UNITED STATES PATENT AND TRADEMARK OFFICE

APPLICATION NO.	FILING DATE	FIRST NAMED INVENTOR	ATTORNEY DOCKET NO.	CONFIRMATION NO.
09/902,037	07/10/2001	Peter R. Bloeme	14081/255319	7782

Office Action Summary

DETAILED ACTION

Fig. 1

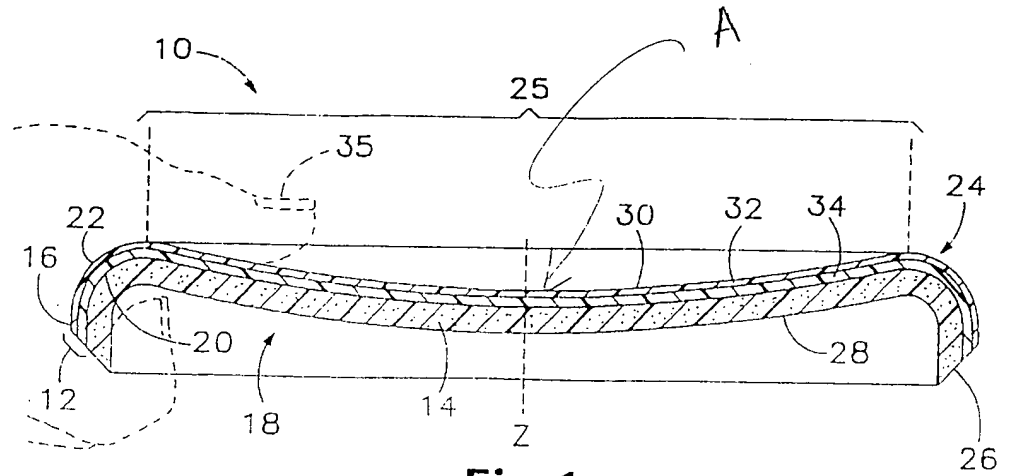
Sneddon discloses in Fig 1 (also see attachment at the end of this Office Action wherein the letter A has been added by the examiner), a disc for being thrown in the air, comprising: an annular rim 22 formed along an outer periphery of the disc and having a diameter of less than 9 inches [6 inches], a flight plate A in a central portion of the disc, a transition area [grippable portion 35] joining the annular rim to the flight plate and

presenting a sloped surface between the annular rim and the flight plate, the flight plate and the transition area having a thickness greater than 0.093 inches [underbelly thickness of one half inch and the exoskeletal thickness of three-sixteenths inch] and the ratio of a height of the flight plate to a diameter of the annular rim is less than 1 to 9.
